Minute No. 374
Report – Standing Policy Committee on Property and Development, Heritage and Downtown Development – May 27, 2019

Item No. 6 **Subdivision and Rezoning – 206, 216, 218, 228, 230, 236, 244 and 248 Good Street**
(Fort Rouge – East Fort Garry Ward)
File DASZ 28/2018 [c/r DAV 184543/2018D]

ADMINISTRATIVE REPORT

Title: DASZ 28/2018 – 206-248 Good St

Figure 3: Main floor height visualization. See Appendix 1 for larger view.

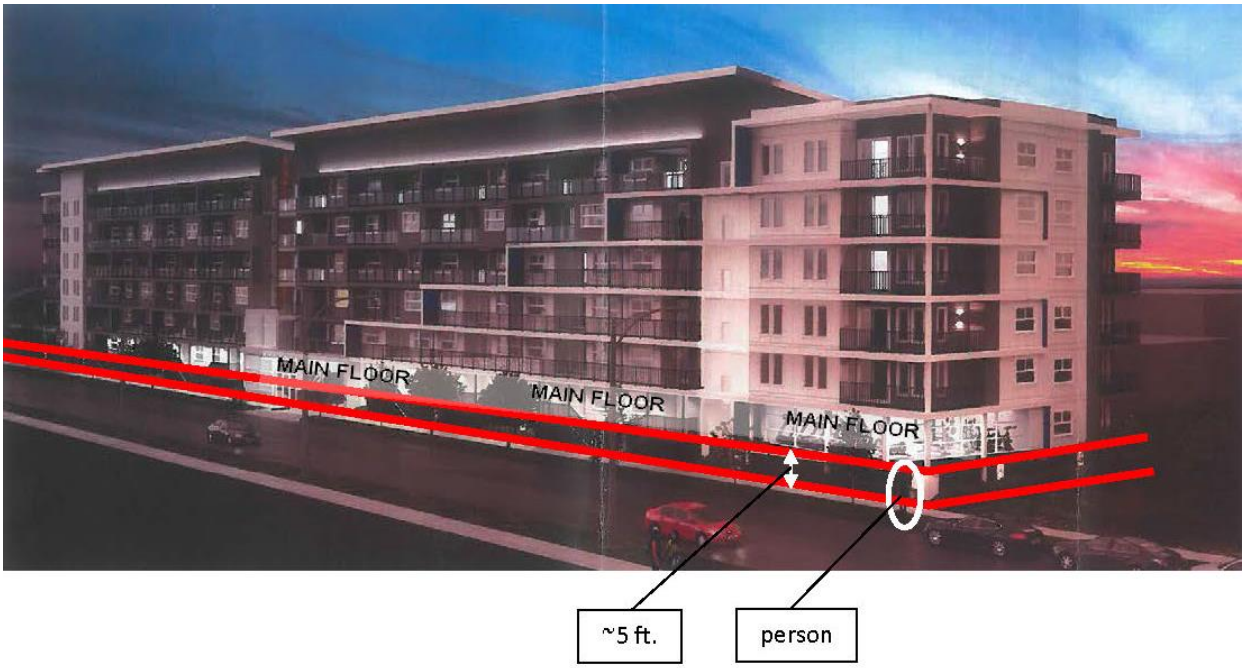
- For the proposed development, the plans show that the building facade on Good St. contains a series of 10-step staircases (5+ ft.) leading up to a raised main floor along the 390 ft. length. Below that, at street level, there is a brick wall with a height of 5+ ft. concealing a parking garage.

- The urban design standard limiting height of the main floor above parking facilities is well recognized and reflected in some cities' residential design guidelines. As an example, the City of Abbotsford's Multifamily Residential Development Permit Guidelines Part V - 2 - 6 MF15 Underground Parking state, *"Avoid designing underground parking that exceeds grade level height. Where underground parking structures must be partially above grade, ensure they do not exceed 1.0 metres from the ground. Use attractive, high quality materials on the exposed structure and/or screen with landscaping."*

Given the above, the Urban Planning Division is not satisfied that the City has been provided information suggesting the parking facility cannot be built fully below grade, or at most 3.3 ft. above grade to its highest point, in order to provide for a supportable building street condition as requested by the City.

- The plans show that the main floor of the building is raised at least 5 ft. above ground level. This removes the 'life' of the building away from street level. It leaves a brick wall

C. That the finished main floor of the building shall not project more than ~~***3.3***~~ ***5*** ft. above grade.
